intel® Technical Advisory

TA-0588-2

SSH4, SPSH4, SRS4 Failure to Expand Adapter Option ROM

Figure 1: Default Option ROM Usage

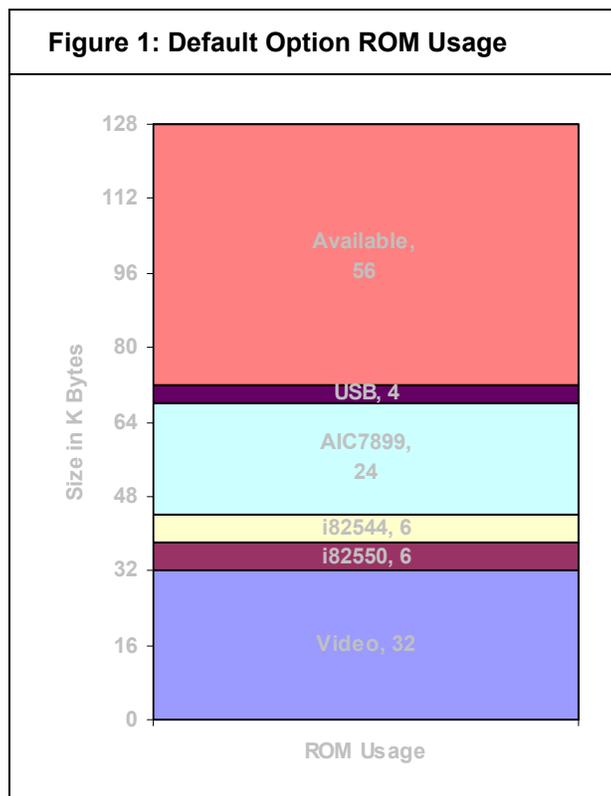
When all of the on-board option ROMs are loaded at boot time, there is a reduced amount of reserved space left for add-in adapter card option ROMs to expand and load (see *Figure 1*). If enough space does not exist for a particular adapter, that adapter's option ROM will fail to expand and will post an error message during system boot.

For example, assume *Adapter A's* (a SCSI adapter) option ROM requests 64K of initial memory and then reduces the final amount

of memory used to 32K. In the example in *Figure 1*, the *Adapter A's* option ROM expansion would fail because the initial request for memory was 64K while 56K is available.

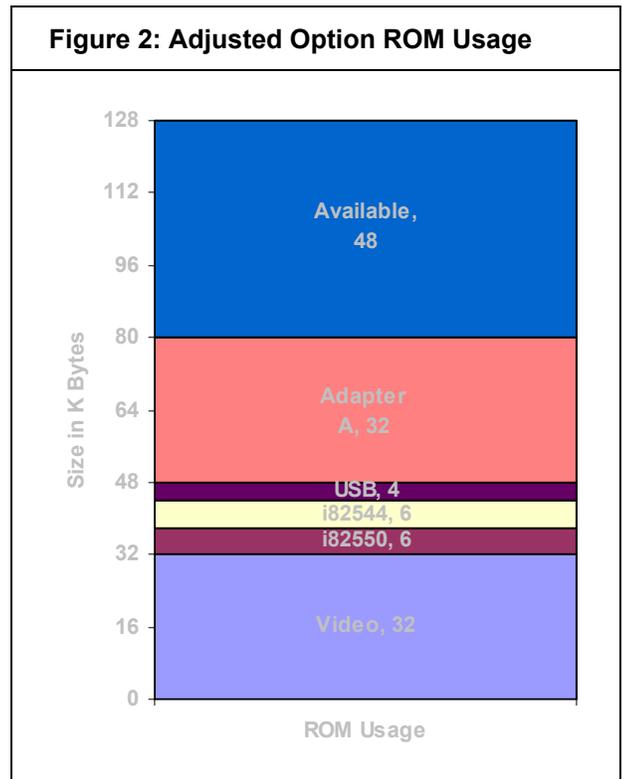
In order to enable *Adapter A's* option ROM to load, adjustments need to be made to the option ROM usage area. Since *Adapter A* is a SCSI adapter, in this example it is determined that the on-board 7899 SCSI controller option ROM can be disabled because it is not going to be utilized as a boot device. By disabling the on-board 7899 option ROM, 24KB of space is release giving a total of 80KB. In this configuration *Adapter A* will pass the initial request of 64KB space, reduce to 32KB, and will successfully load leaving a memory usage map similar to that shown in *Figure 2*.

Intel recommends that option ROM scanning be disabled for any device or PCI slot that does not require the option ROM for a boot device, or other functionality such as RAID management.

SSH4 BIOS P06 fixes this issue by moving legacy USB into the EBDA area of the BIOS this returns the 16k assigned to Legacy USB to the available space as illustrated above. In addition by optimizing the BIOS code another 59k has been added to the space available for the expansion of adapter option roms. This is an increase of 59 k bringing the total space for add-in adapter option roms to 107 k
